Our ref: 10724
Council ref: MCU18/0221

10 August 2023

**RE: REQUEST TO CHANGE OTHER CHANGE APPLICATION (COUNCIL REF: MCU18/0221)
156-168 SERPENTINE CREEK ROAD, REDLAND BAY QLD 4165**

Figure 11: Approved Off Road Cycle Path Locations (Jensen Bowers)

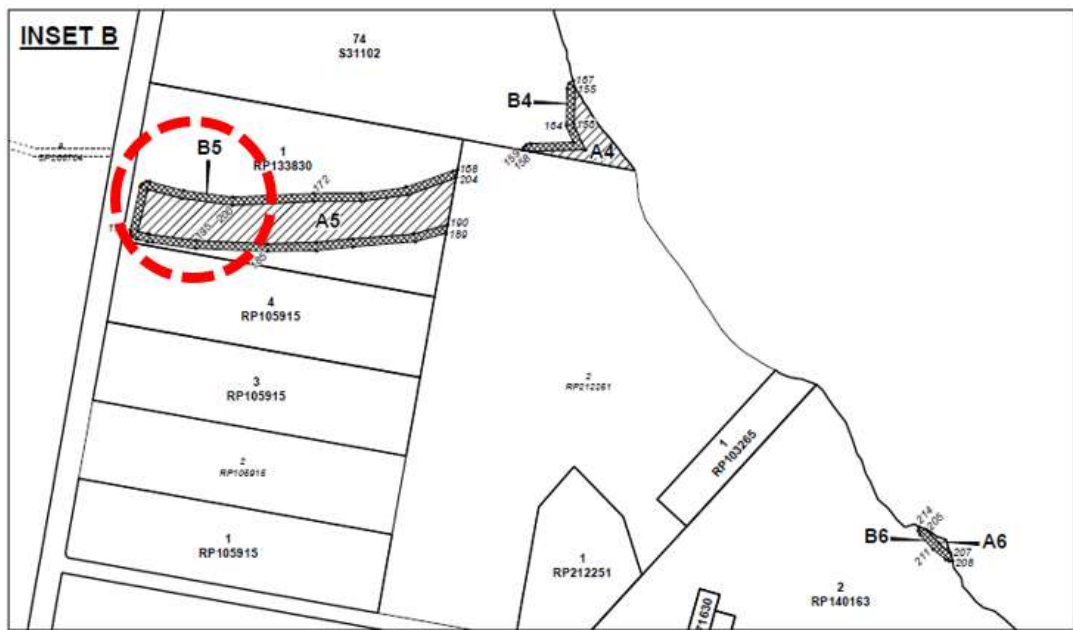
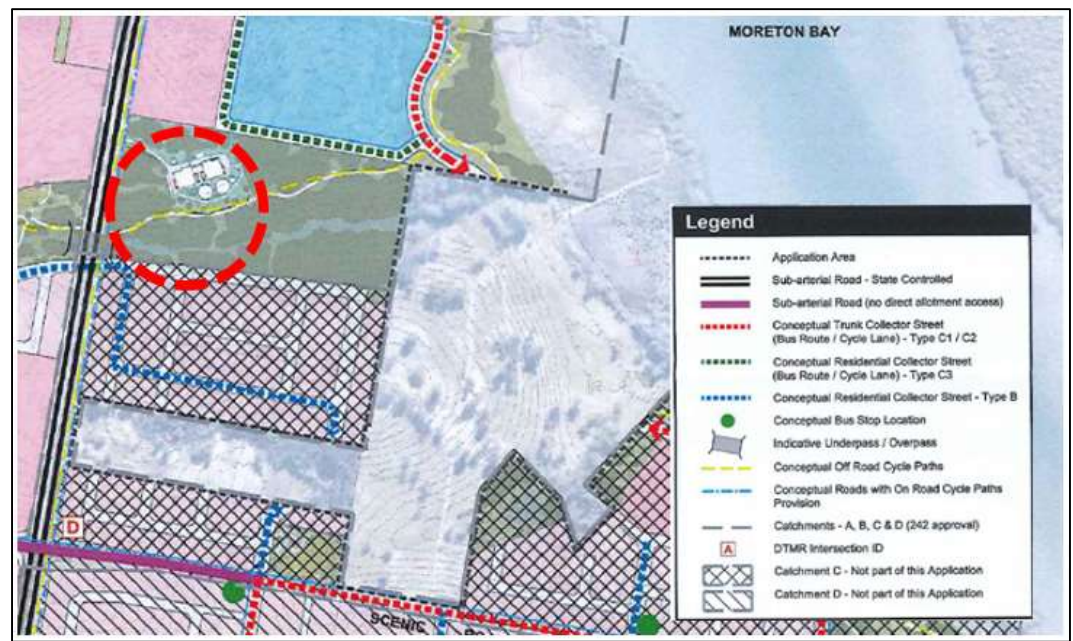
Conflicts were identified at current lot 1 on SP289245, conditioned by Redland City Council to be dedicated as 'Conservation Park' with the extent of the dedication area to be confirmed pending further ecological assessment. This lot is also subject to State approval conditions which identify the Referral Agency Response (Vegetation) Plan (RARP) mapped areas and require that the clearing of native vegetation must not occur

within Area A, as shown on the approved plan. Despite this, an approved off road cycle path was positioned centrally within this area. Refer to **Figures 10 and 11**.

Noting the significance of the incompatibility, this application seeks to amend the approved conceptual location to ensure that consistency with the conditions of approval can be maintained. The proposed off road path has consequently been realigned to the north of the lot. This will ensure that future works associated with the connection can avoid impacting RARP Areas and habitat values, and without compromising the extent of future areas to be dedicated for conservation purposes. It is acknowledged that the preliminary approval has focussed heavily on the facilitation of movement within and beyond the estate,

Figure 13: DSP02 – MCU18/0220 Approved WSUD Strategy (Design Flow) and DSP02 Location (Jensen Bowers)

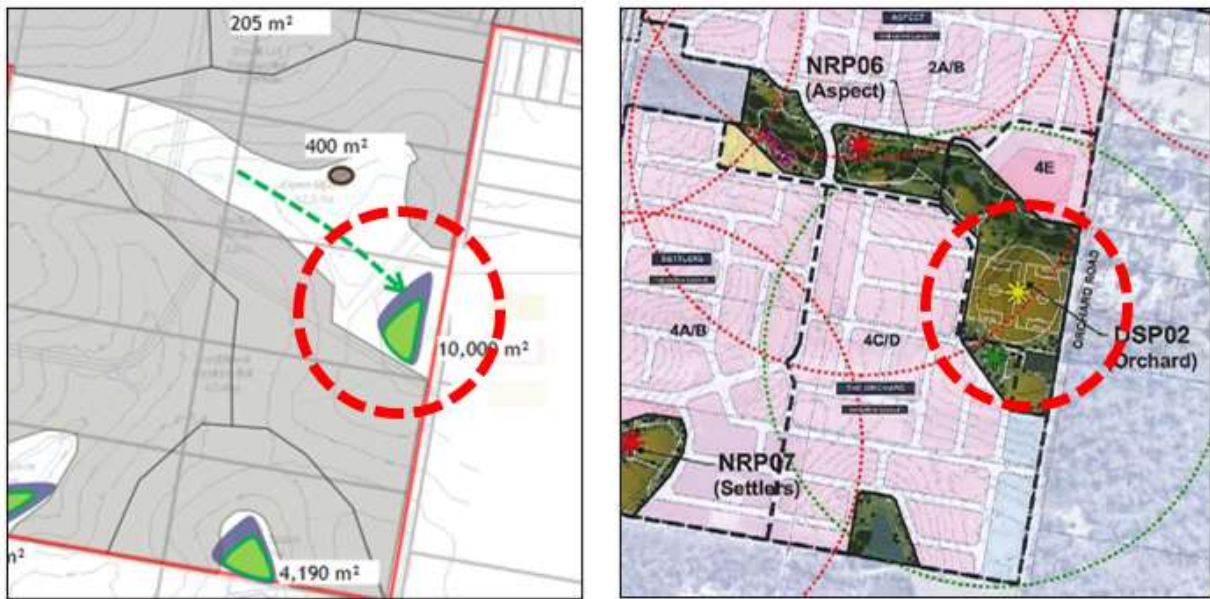
- The previously identified flood detention basin located within NRP01 was not required and a bioretention basin was sufficient (refer to **Figure 12**); and
- The wetlands / flood detention solution located on Lot 86 on S312432 was positioned within DSP02 and would require resolution (refer to **Figure 13**).

To resolve the conflict at DSP02, a stormwater management strategy review determined that drainage functions could be relocated north and that DSP02 could be relocated south. This allows the DSP to remain fully functional while addressing the revised water sensitive urban design requirements. Accordingly, the Open Space Precinct and WSUD Strategy have been amended to ensure stormwater functions are located predominantly within the linear park to the north and minimal drainage functions within the DSP. Similarly, NRP06 has been repositioned to the west to ensure minimal stormwater functions are positioned within it (refer to **Figure 14**, below).

Figure 16: Potential Refreshment Establishment areas as shown on the proposed Shoreline POD Precinct Plan

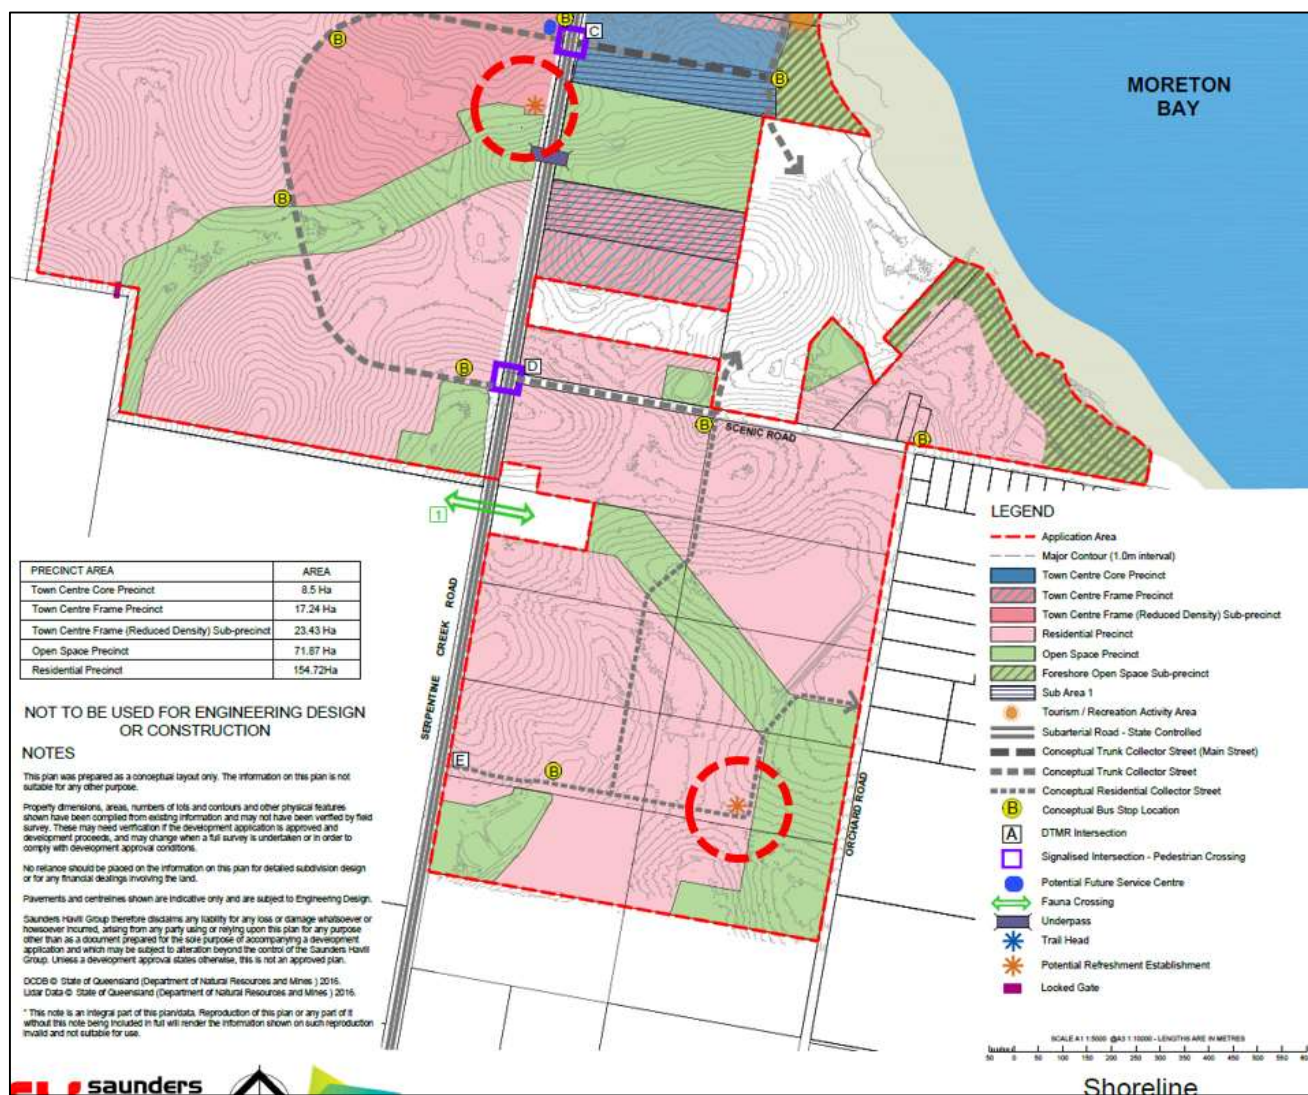
The proposed Shoreline POD Precinct Plan includes two Potential Refreshment Establishment areas identified: one located within the Town Centre Frame (Reduced Density) Sub-precinct (adjacent to Serpentine Creek Road at the west, refer to **Figure 16**, over page.

Accordingly, the Shoreline Town Centre Frame Precinct – Categories of development and assessment for Material Change of Use of Premises (Section 3.3.1) has been amended to allow for Refreshment Establishment use within the Reduced Density sub-precinct in the following scenarios:

- As Accepted development subject to requirements where *located at or in the vicinity of a Potential Refreshment Establishment as shown on the Shoreline POD Precinct Plan and complying with the assessment criteria being the acceptable solutions in column 3.*
- As Code Assessable development where *located at or in the vicinity of a Potential Refreshment Establishment as shown on the Shoreline POD Precinct Plan and – (1) Having 400m² or less gross floor area.*
